Alberta Utilities Commission

Decision 29226-D01-2025

Fox Meadows Wind Inc.

Fox Meadows Wind Project

Figure 2. Project area and whooping crane migration corridor

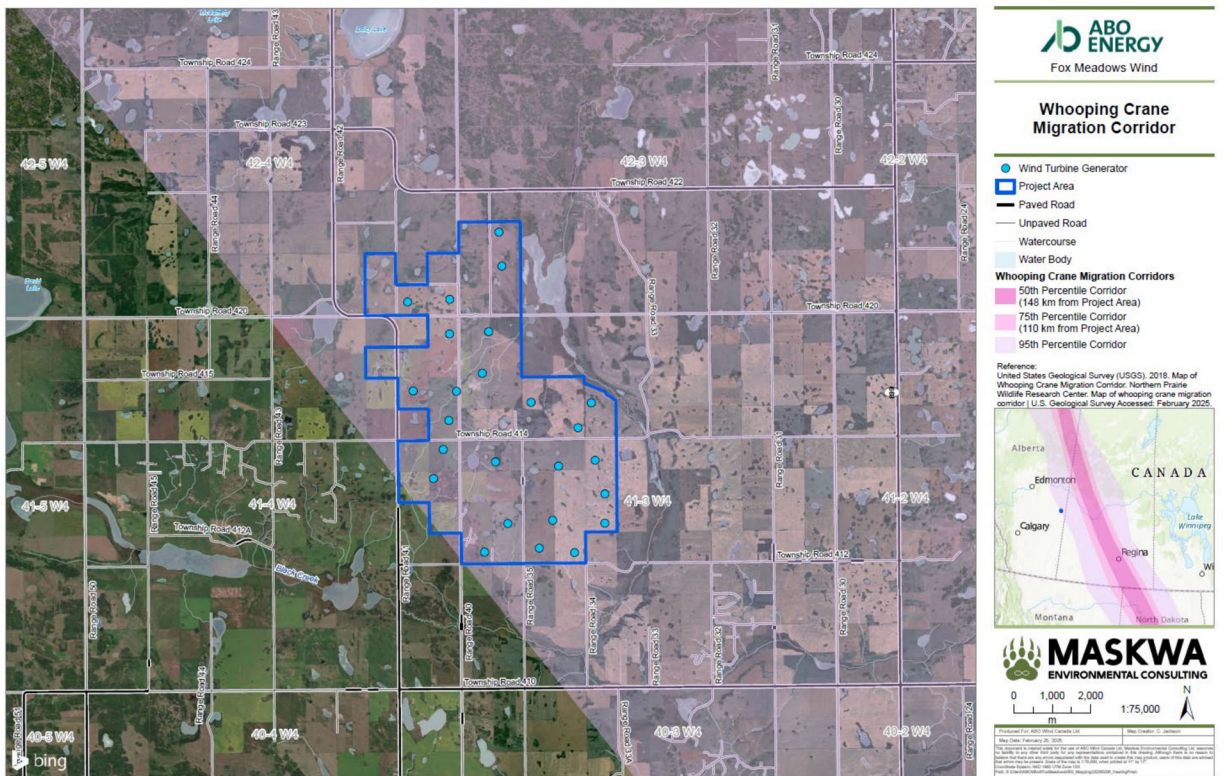
54. Submissions in C. Wallis’s evidence included a figure showing historical records of whooping crane near the project area. However, the Commission noted that concentrations of observations were primarily east of the project, and areas of extended use were absent in Alberta, with the exception of their breeding grounds in northern Alberta.²⁶ The Commission requested an undertaking for geospatial maps which showed the likelihood that whooping crane would travel through the project area. A map was submitted to the record which showed that the project was located in the 95th percentile corridor, meaning that 95 per cent of the population travelled within the bounds of this area (see Figure 2).²⁷

55. In the Commission's view, it is important to explain Figure 2 for clarity. Instead of interpreting this figure as showing that 95 per cent of whooping cranes will travel through the project area, it is important to consider the 50th percentile corridor and 75th percentile corridor in conjunction with the 95th percentile corridor. As a whole, this figure is showing that a majority of the population migrates in a concentrated corridor east of the project, with a very clear focal point through Saskatchewan and northern Alberta, and occasionally individuals will stray from this concentrated migration corridor towards the 95th percentile corridor. However, as distance from the 50th percentile corridor increases, population stray becomes less likely.

- a. Fox Meadows Wind Inc. shall submit an annual post-construction monitoring survey report to Alberta Environment and Protected Areas no later than January 31 of the year following the mortality monitoring period and submit the annual post-construction monitoring survey report and Alberta Environment and Protected Areas' post-construction monitoring response letter to the Commission within one month of its issuance to Fox Meadows Wind Inc. These reports and response letters shall be subsequently filed with the same time constraints every subsequent year for which Alberta Environment and Protected Areas requires surveys pursuant to Section 3(3) of Rule 033: *Post-approval Monitoring Requirements for Wind and Solar Power Plants*. Post-construction monitoring must include a survey of the power lines and transmission lines that service the project and are located within any percentile of the whooping crane migration corridor.

- c. All overhead power lines and transmission lines will have strike diverters, or additional superior mitigations, installed with the intention of avoiding whooping crane collisions. Fox Meadows Wind Inc. must ensure that a mitigation plan, which specifically addresses transmission line collision risk for whooping crane, is submitted during the future application for the transmission line associated to the project, and Alberta Environment and Protected Areas must be informed of, and provided a copy of, this mitigation plan.
